**For FC1 elevator and  
VT system push rod**

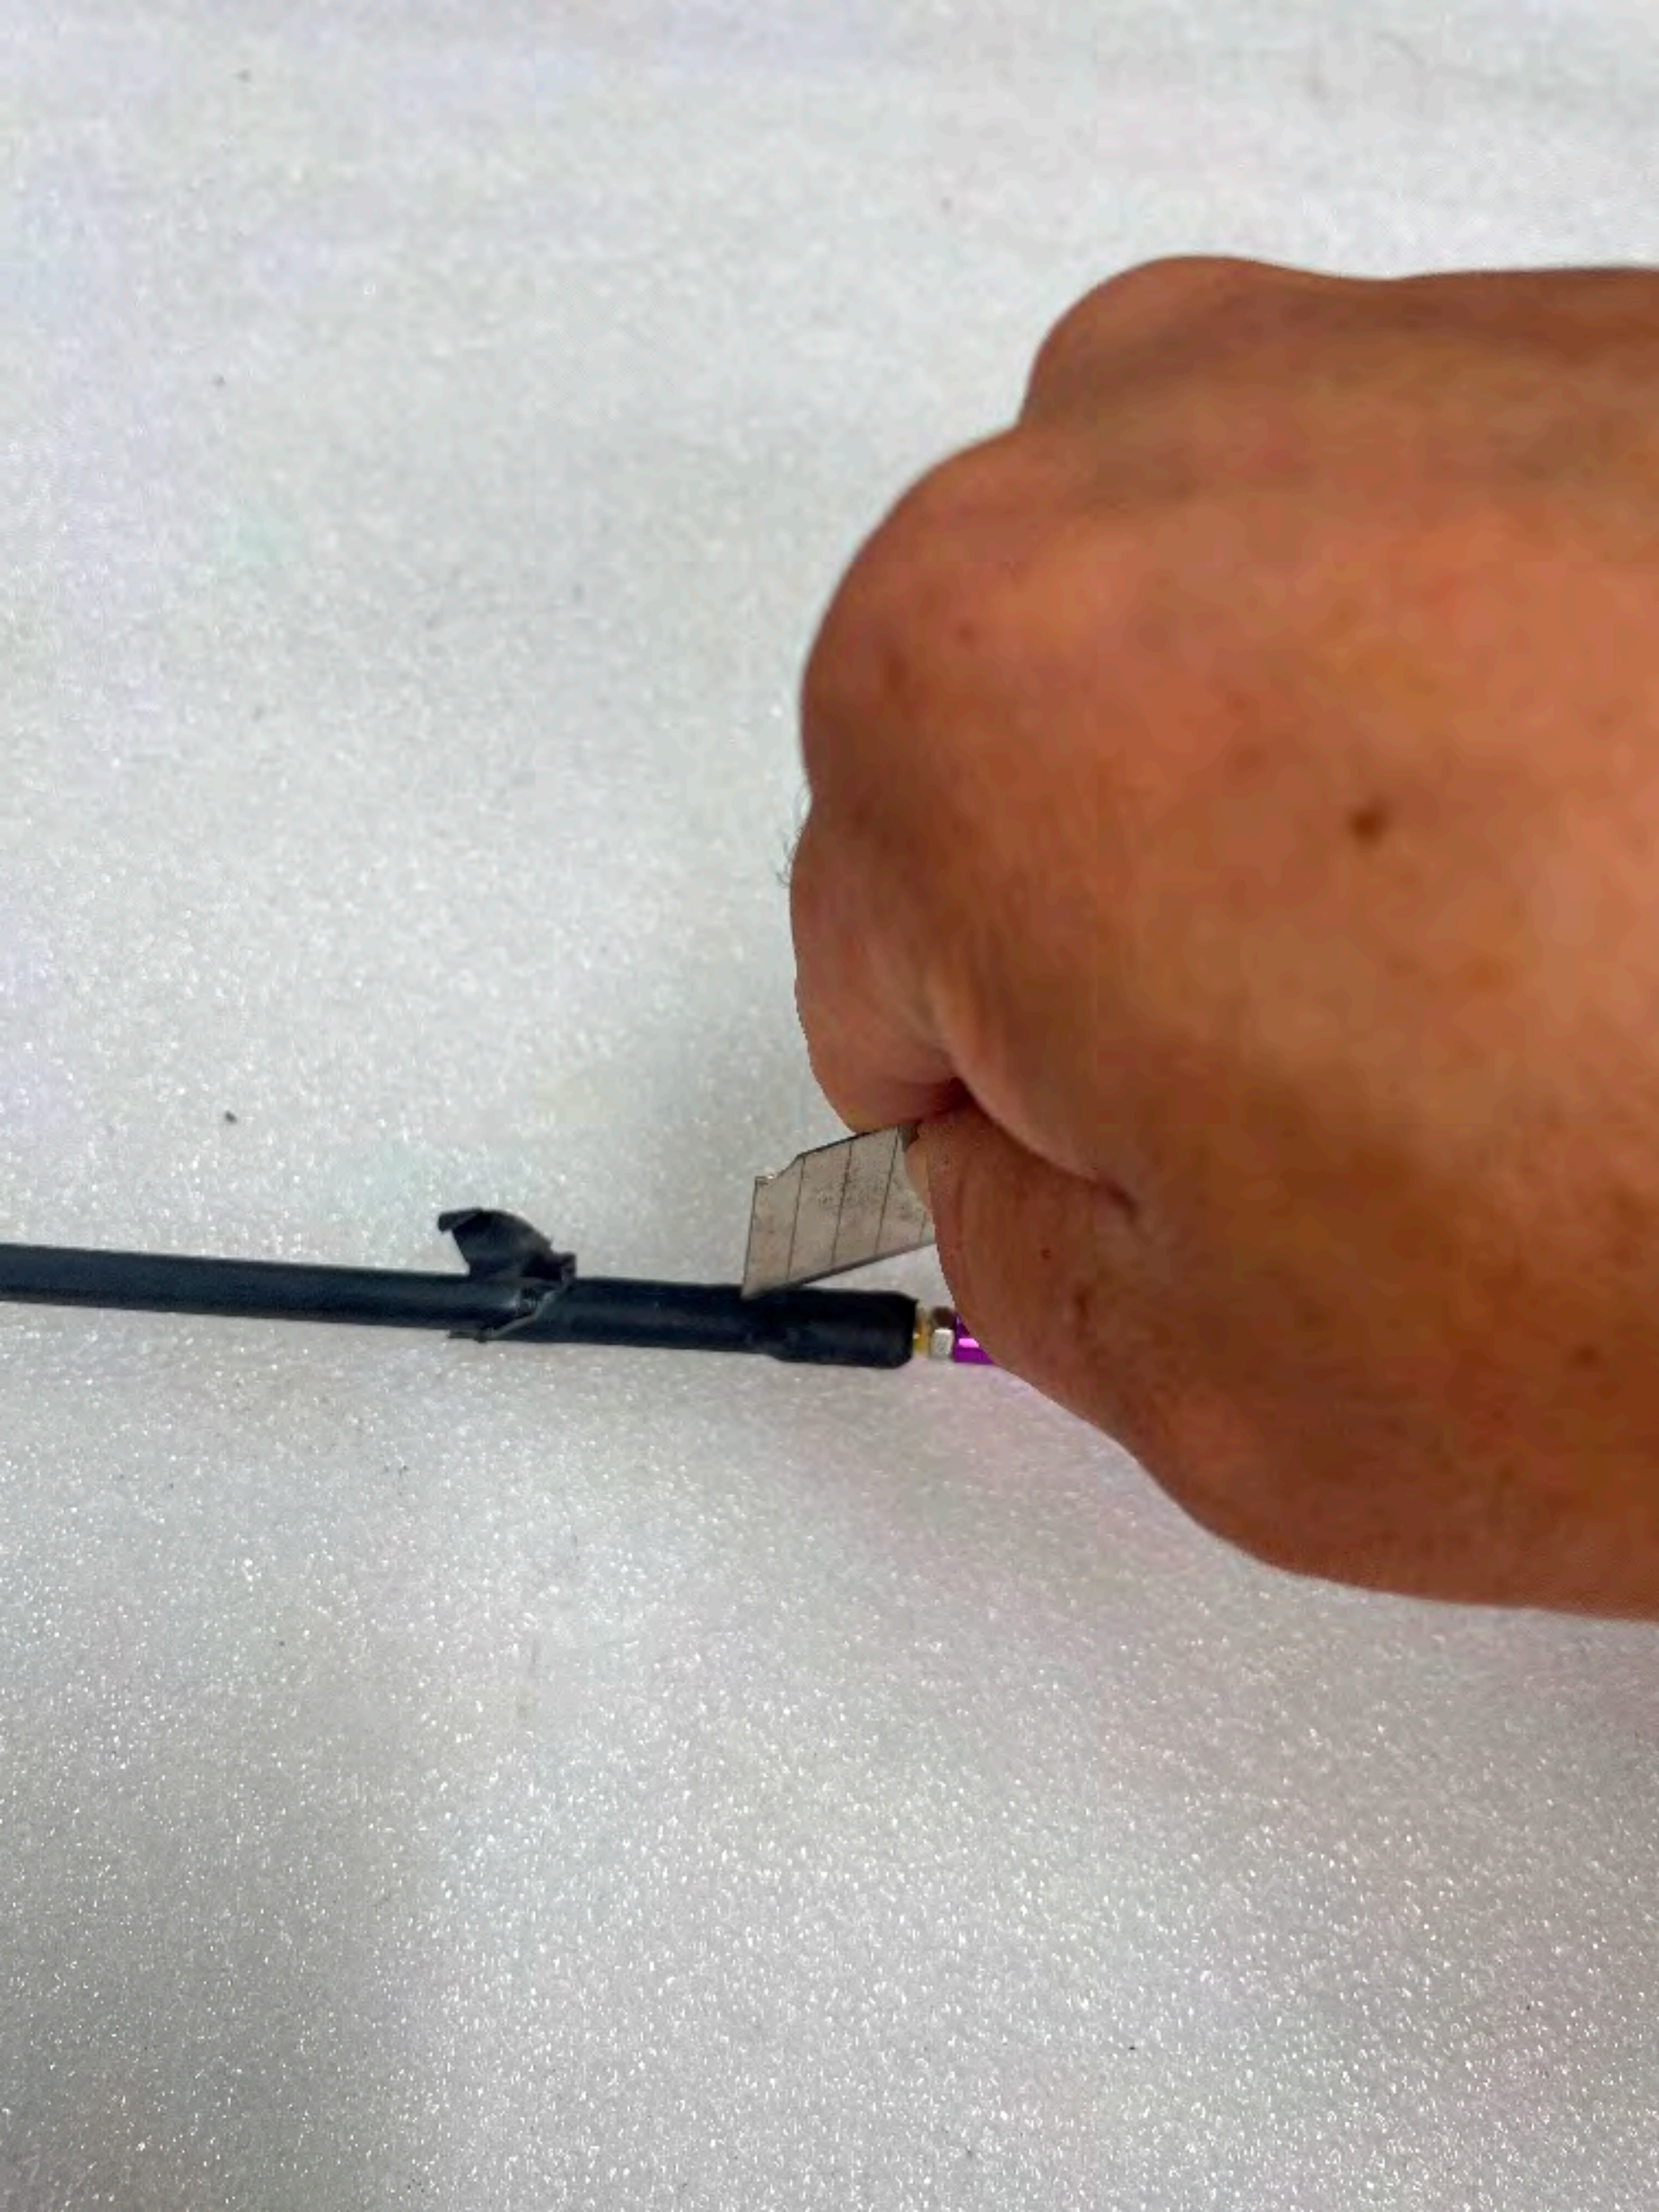
the brass part on the carbon  
tube rod maybe not strong  
enough. it maybe broken  
from the red position

steel part is strong enough  
and it does not broke even I  
bent it with high stress

Pilot-RC will send you the  
stainless steel part so you can  
replace. please do not fly it  
before you replace it.

Heat the brass part by hot gun or hairdryer
